USAR P.C. 2.4-3-85	
DESIGNED BY	DRYDEN
CHECKED BY	DRYDEN
DATE	NOV 1984
REVISED FOR	REVISED FOR THE 2003-04AS
WOLF CREEK ELECTRONIC APPROVAL WOLF CREEK GENERATING STATION MANHOLE AND PIPE DETAILS AS SHOWN S-0191 SHEET NO. 26 OF 26

DESIGN DOCUMENT
CHANGE NOTICE

ASSIGNED DISCIPLINE: FACILITIES ENGINEERING	DDCN NO.	DOCUMENT NUMBER S-0297	REV. K	SEQ. NO. 01
---	----------	----------------------------------	------------------	-----------------------

PLANT AREA ROADWAY GRADING & DRAINAGE

S-0297

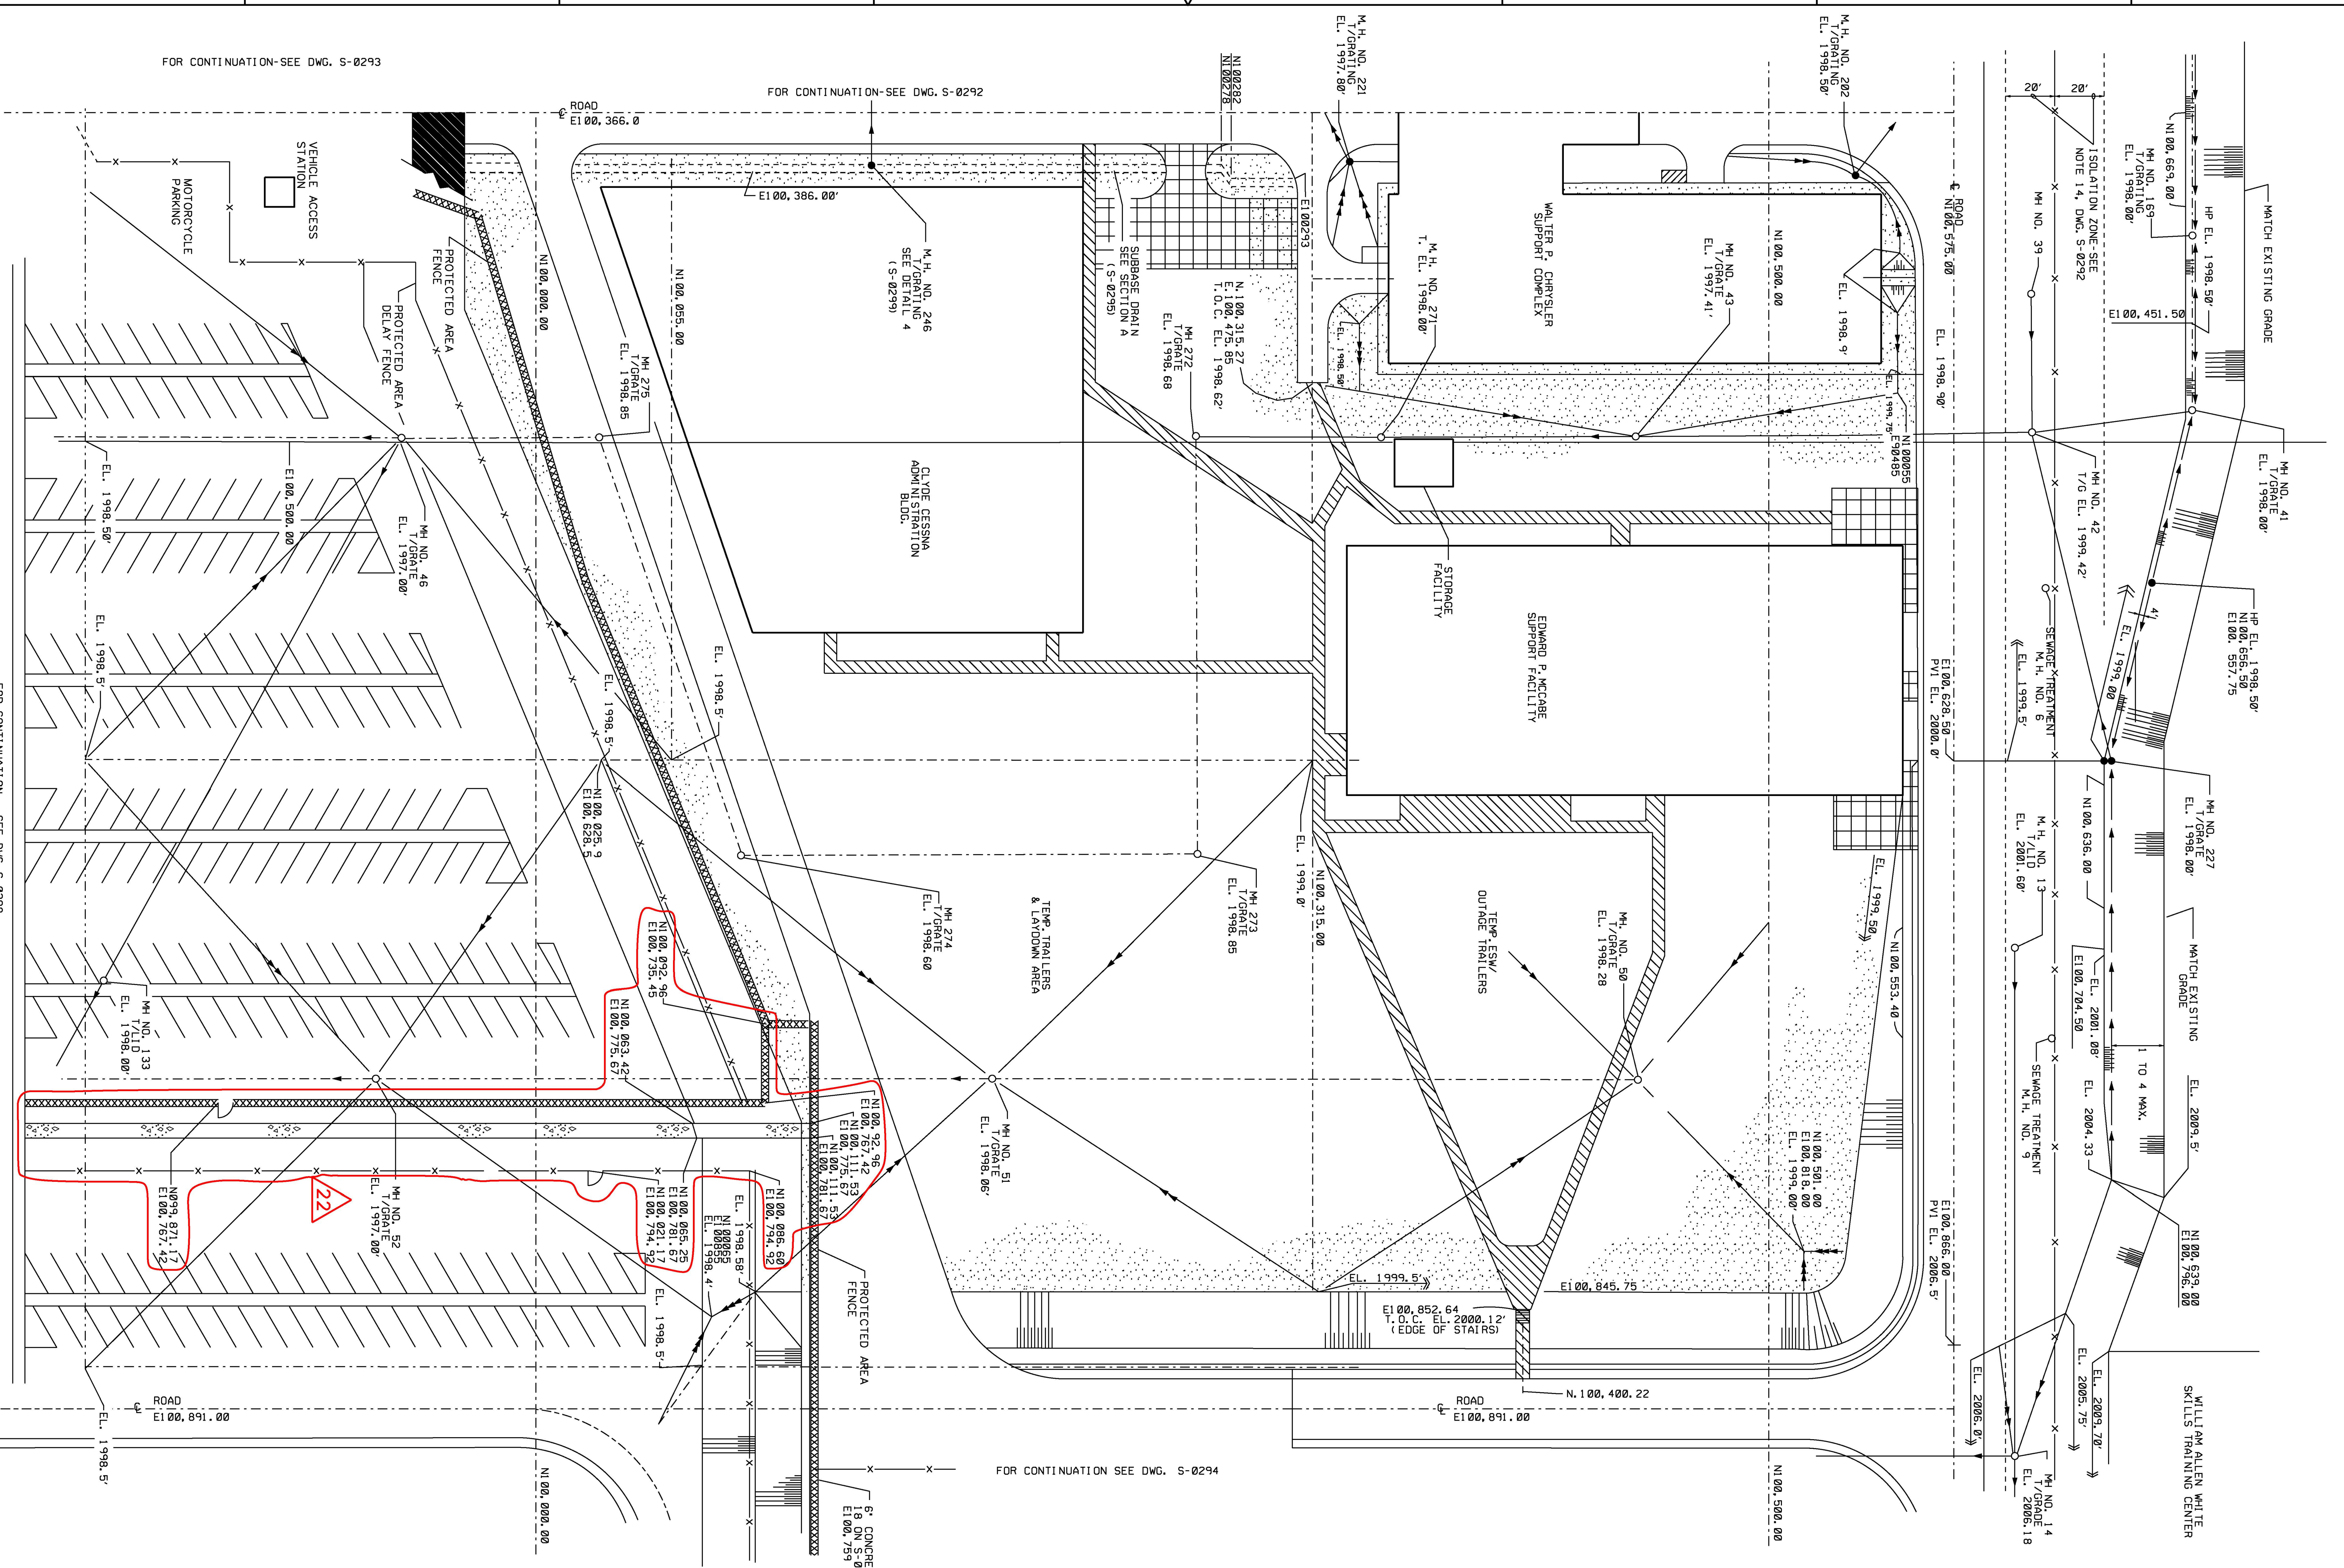
REASON FOR CHANGE:
AS BUILT INFORMATION

DESCRIPTION OF CHANGE: **SEE CLOUDED "AREA OF CHANGE" ON PAGE 2 OF THIS DDCN.**
